**CCL 27/09/16
ENDORSEMENT OF PROPOSED AMENDMENT TO LOCAL ENVIRONMENTAL
PLAN 2012 –RAIL CORRIDOR LAND BETWEEN WORTH PLACE AND WATT
STREET NEWCASTLE**

Attachment D: Urban Design Consultative Group reports from 11 July 2016
and 17 August 2016

Name of Project (if applicable): Rail Corridor Rezoning Associated DCP Guidelines

Attachment E: Master Plan (Urban Growth NSW) and detailed parcel analysis of submitted proposal (NCC August 2016)

Parcel 11

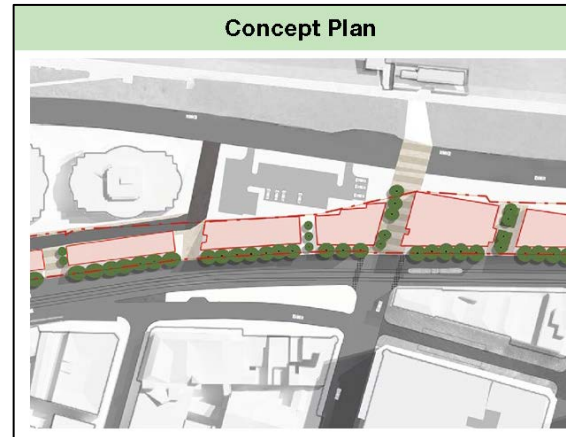
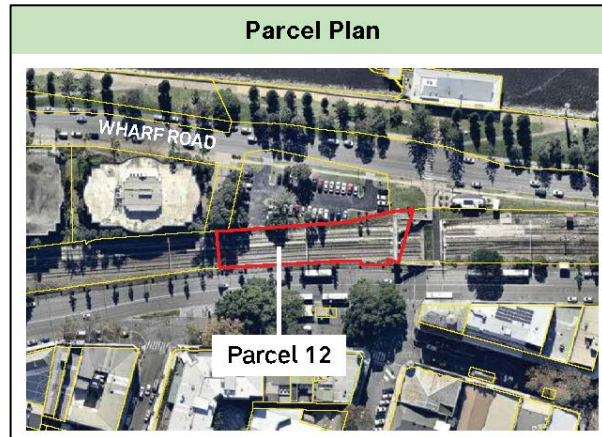
The narrowness of the strip of land east of Darby Street (Parcel 11) that will be available from the railway closure, was such that any residential use above small ground-floor retail spaces was likely to offer very poor amenity because of lack of aspect or solar access. The site(s) also offer difficult access for residential/ retail uses. The existing apartment building and office blocks to the north of the corridor that are accessed from Wharf Road, look directly onto the rail corridor site at minimal setback.

The sketch sections and plans provided by UrbanGrowth (August 17 presentation) to test the feasibility of shop-top housing on Parcel 11 confirm that such an approach may be viable (in the form of ground floor commercial with two storey walk-up apartments above), but the amenity of these apartments is likely to be compromised by multiple site factors. Furthermore, this location is not ideal for housing of any type, although a hotel may be more appropriate. The UDCG also raised the possibility that Parcel 11 might be able to accommodate a narrow carpark, but sketch plans provided by UrbanGrowth suggest that there is insufficient site width for a double-loaded carpark, potentially undermining its feasibility.

Given the problems inherent in using Parcel 11, it may be better to investigate an alternative, landscape and pedestrian focused urban space, to visually continue the open green spaces along this length of corridor, towards the east.

Parcel No. 11	Submitted Proposal (Urban Growth NSW)	Urban Design Consultative Group	Council Planning Proposal (Attachment A)
	Justification - Proposed mixed use development, including residential terraces. - Location for substation at western end on the adjacent Parcel 10. - Provides rear access from Argyle Street to development parcel fronting Hunter Street. - Activates and responds to built form to the south side of Hunter Street. - Buildings to the north are taller and front onto Wharf Road. Proposed backs of buildings to be to the north.	Due to narrow depth development of parcel will be challenging to support residential with adequate amenity and access.	In response to UDCG applicant has provided further justification: Given need to achieve better building separation and access suggest reducing FSR to 1.5:1 which is also consistent with land to the north. <u>Outcome</u> Support the submitted proposal, but with the reduced FSR at 1.5:1. Due to the narrow depth of this parcel the redevelopment of this parcel will be challenging. It is considered that lower building forms, such as terraces, could be accommodated. This parcel contains the heritage listed AA Co, bridge and fence and would ideally be integrated with future built form and will be detailed in the DCP guidelines developed post

Parcel No. 11	Submitted Proposal (Urban Growth NSW)	Urban Design Consultative Group	Council Planning Proposal (Attachment A)
	Requested LEP amendments • Zone B4 Mixed Use • Height 14m • FSR 2.5:1 Potential yield • Parcel area 4,542m² • Non-residential 1,000m² • Dwellings 95		Gateway. The access to rear of development will also be detailed in the DCP guidelines. Proposed LEP amendments • Zone B4 Mixed Use • Height 14m • FSR 1.5:1

Parcel 12

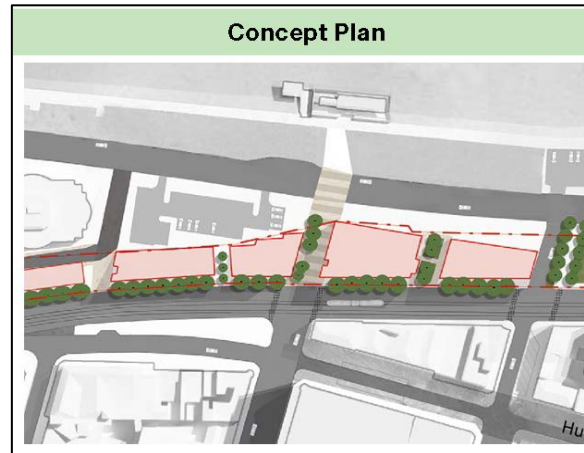
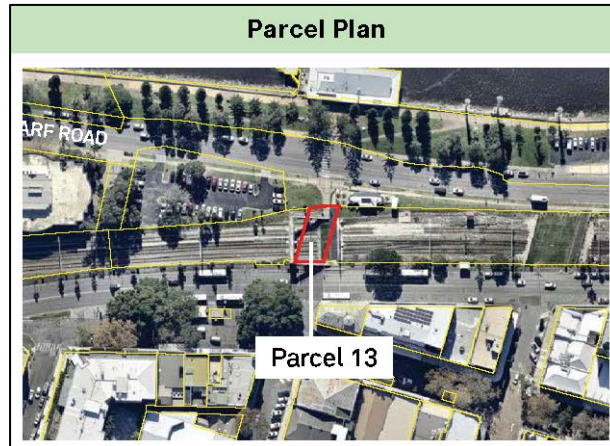
Parcel No. 12	Submitted Proposal (Urban Growth NSW)	Urban Design Consultative Group	Council Planning Proposal (Attachment A)
	Justification Proposed to be a mixed use development to reflect and frame the development south of Hunter Street. Revitalises and activates Scott Street and respects built form surrounding the site to the west and south. New linkage will be created from Parcel 13. Proposed development can provide activation and surveillance to Parcel 13. Built form will respond to retaining visual connection. Pedestrian connectivity and through site linkage between Hunter Street and Wharf Road. Access to Scott Street and Wharf Road.	There is an opportunity to create a significant “interface” on this parcel that could incorporate both the corridor and the space currently occupied by a Council owned at-grade car park. A building on this parcel, to the east of the existing glass-walled office structure, should be orientated to the green space to its east, and could mark the easternmost end of the established line of development on the northern side of Hunter Street, as it meets the new public open spaces. A 17m height limit was considered potentially acceptable on this site. The three small, low rise sites to the east of this, shown on the	In response to UDCG applicant has provided further justification: Rezoning of Council car park to north is a matter for Council to consider. If Council is of a mind to do so Urban Growth could consider a land swap through a planning agreement to achieve improved configurations. <u>Outcome</u> The submitted proposal is supported with modification. It is proposed to zone the western portion of Parcel 12 SP3 Tourist Zone with the remainder to be zoned RE1 Public Recreation. A key objective to the revitalisation of the Newcastle City Centre has consistently been to enable development that contributes to improving the connection between the City and the waterfront. Such aspirations are included within the NURS, the neighbourhood visions

Parcel No. 12	Submitted Proposal (Urban Growth NSW)	Urban Design Consultative Group	Council Planning Proposal (Attachment A)
	Requested LEP amendments • Zone B4 Mixed Use • Height 17m • FSR2.5:1 Potential yield • Parcel area 1,544m² • Non-residential 500m² • Dwellings 50	'Master Plan: Proposed Planning Amendments' page, are isolated and provide very limited development opportunity, while potentially shutting down both views and access to the harbour and interrupting the historic street grid. These three small sites (Parcel 14) should be included in the proposed open space.	under Council's Local Planning Strategy, and also carried forward into Urban Growth NSW own NUTTP. The available land in this locality should be taken as an opportunity to improve the relationship from the public domain of the waterfront back to the historic northern edge of City East (along Scott Street). While the master plan proposes to maintain corridors based upon extension of the 'Dangar street grid' and to provide an extension of the street wall/activation of Hunter Street in this location, the opportunity to maintain the openness between the waterfront and the historic northern edge of City East is available. It is important that the new 'Harbour Lawns' of the 'Entertainment Precinct' have active and vibrant edges. Therefore a balance is required between enabling some development while also ensuring adequate connection between city and waterfront. Therefore it is considered that the introduction of built form on Parcel 12 would assist in achieving activation of this space. It is recommended that any development needs to be positioned and orientated to the east to enhance the north-south connection and provide passive surveillance and activation/integration opportunities with the adjoining open space. In this manner Parcel 14 would serve greater public benefit as open space. Given the prominent nature of Parcel 12 now 'book-ending' the open space it is proposed to

Parcel No. 12	Submitted Proposal (Urban Growth NSW)	Urban Design Consultative Group	Council Planning Proposal (Attachment A)
			include the site on the key sites map to ensure a high quality design outcome is achieved. There is an opportunity to include Council's current at-grade car park on Wharf Road, adjacent to Parcel 12, into a consolidated development lot to achieve an improved design outcome. This would provide an improved interface with Wharf Road, improved activation to the open space, provide for public car parking within the development and could also assist in balancing some development yield lost, from the deletion of development on Parcel 14. The UDCG support this carpark consolidation opportunity as it would enable improved built form outcomes and better enable orientation of building forms to the east. To include the Council site within this Planning Proposal would require a reclassification and rezoning of public land. It is considered that doing so may complicate the proposal and potentially add to community confusion during any public exhibition/public hearing process post Gateway. The proposed B4 Mixed Use zone for Parcel 12 is considered problematic. This zone would tend to encourage residential development which would remove this space from the public realm and conflict with the aim for a vibrant entertainment precinct adjacent. To address this issue an SP3 Tourist zone is proposed for part of the land. It is therefore proposed to zone approximately half of Parcel 12 to SP3 Tourist zone with

Parcel No. 12	Submitted Proposal (Urban Growth NSW)	Urban Design Consultative Group	Council Planning Proposal (Attachment A)
			further investigations into the adjoining car park land to occur separately. Proposed LEP amendments: • Zone SP3 Tourist and RE1 Public Recreation • Height 17m • FSR 2.5:1

Parcel 13

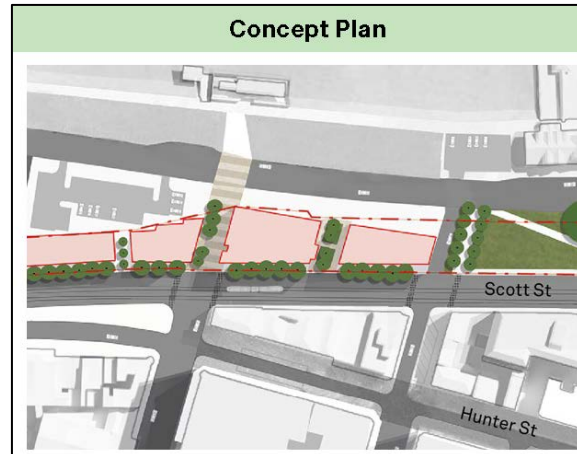
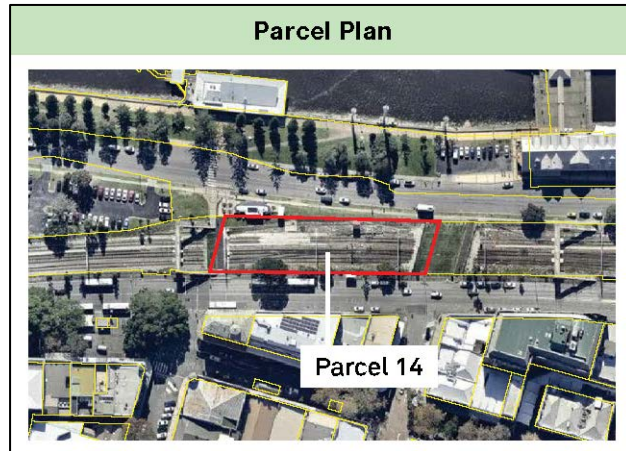
Parcel No. 13	Submitted Proposal (Urban Growth NSW)	Urban Design Consultative Group	Council Planning Proposal (Attachment A)
	Justification • Creation of a new formal public recreation and linkage area. • Significant public realm improvements. • Create pedestrian connectivity between Scott Street and the harbour via an extension of Perkins Street. • Through site and visual linkages. • Can be dedicated to Council. Requested LEP amendments • Zone RE1 Public Recreation Potential yield • Parcel area 303m² • No development proposed	Support open space.	Submitted proposal supported. Zoned for RE1 Public Recreation zone.

Parcel 14

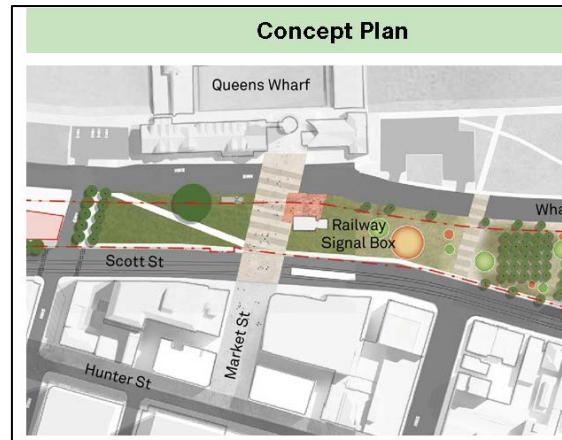
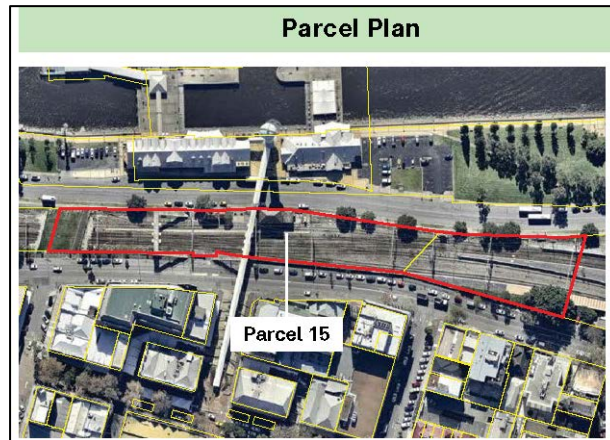
- Parcel 14 should be public open space. Any development on this parcel will unnecessarily separate the city and the harbour. It would be more valuable to extend the public realm plan from Parcel 15, to include Parcel 14.

Parcel No. 14	Submitted Proposal (Urban Growth NSW)	Urban Design Consultative Group	Council Planning Proposal (Attachment A)
	Justification - Proposed to be a mixed use development that fronts Wharf Road, Scott Street and Wolfe Street. - Supports and retains surveillance over the public realm improvements. - Provides a frame for Parcel 15 which would otherwise be long and unactivated. - Built form controls will be in NDCP to ensure view corridor. - Assists to activate Scott Street at the east end. - Access to Scott Street and Wharf Road. - Revitalises, activates and defines the public space at the east end.	Parcel 14 should be public open space. Any development on this parcel will unnecessarily separate the city and the harbour. It would be more valuable to extend the public realm. See also comments for Parcel 12.	In response to UDCG the applicant has provided further justification: - The development of B4 Mixed Use would assist activating Scott Street. The existing section between Perkins and Wolfe Streets offer no ground level activation. - Without this parcel developed the extent of open space is excessively long and would be difficult to activate. Would assist focussing open space on the Market Street connection. - Provides a transition of scale to the open space of Parcel 15. - View corridors between parcels is maintained. <u>Outcome</u> Submitted proposal not supported. To be zoned RE1 Public Recreation.

Parcel No. 14	Submitted Proposal (Urban Growth NSW)	Urban Design Consultative Group	Council Planning Proposal (Attachment A)
	Request LEP amendment • Zone B4 Mixed Use • Height 14m • FSR 2.5:1 Potential yield • Parcel area 2,251m² • Non-residential 500m² • Dwellings 70		Proposed LEP amendment • Zone RE1 Public Recreation • No height or FSR

Parcel 15

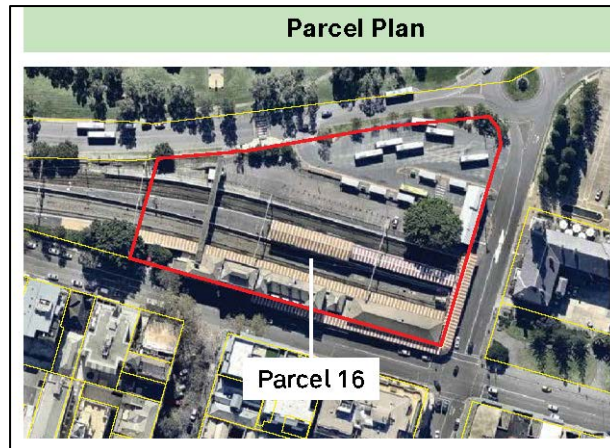
Parcel No. 15	Submitted Proposal (Urban Growth NSW)	Urban Design Consultative Group	Council Planning Proposal (Attachment A)
	Justification - Proposed to be public recreational space. - Significant public realm and landscaping. - improvements for the community with community activities. - Pedestrian connectivity between Scott Street and Queen's Wharf. - Pedestrian linking and visual corridor from Market Street to Queens Wharf. - Access to Scott Street and Wharf Road. - Allowing for repurposing of the Signal Box to support community events.	An active open-air entertainment precinct was seen as a positive inclusion. It could incorporate active spaces such as half basketball and/or half tennis courts, and ongoing, programmed, activities along the lines that the open spaces around Federation Square (Melbourne) are used for performances and other occasions.	Submitted proposal supported. Proposed RE1 Public Recreation zone.

Parcel No. 15	Submitted Proposal (Urban Growth NSW)	Urban Design Consultative Group	Council Planning Proposal (Attachment A)
	Requested LEP amendment • Zone RE1 Public Recreation Potential yield • Parcel area 7,713m² • No development proposed
